marantz® SERVICE BULLETIN		Date: 27-Jan.-2004	Model: SR8300/SR9300
		Page: 1 / 3	REF.NBR: MZ04-010
Circulation:		Subject:	
Application:		SETUP sometimes returns to initial setting.	
x for information customer complaint in case of service mandatory			
		See Below

marantz® SERVICE BULLETIN		Date: 22-Apr.-2004	Model: SR8300/SR9300
		Page: 1 / 1	REF.NBR: MZ04-035
Circulation:		Subject:	
Application:		After specific operation, SETUP sometimes returns to initial setting.	
x for information customer complaint in case of service mandatory		ALL	
		Int.ref:

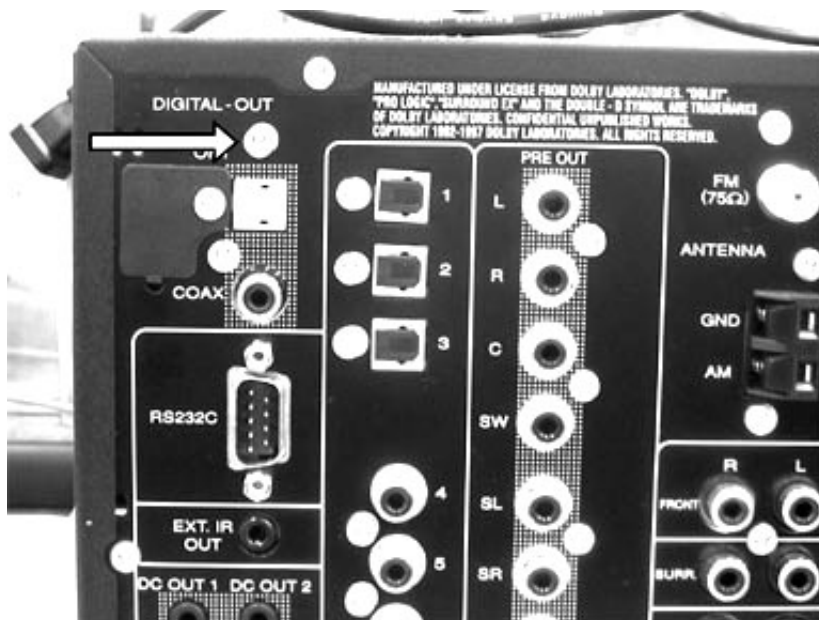
Use RS232C Dsub-9 pin cable (female to female/Straight type) to connect PC and the unit.

COM port on PC needs to be set by dialog box for each program. COM port can be set from COM1 to COM5.
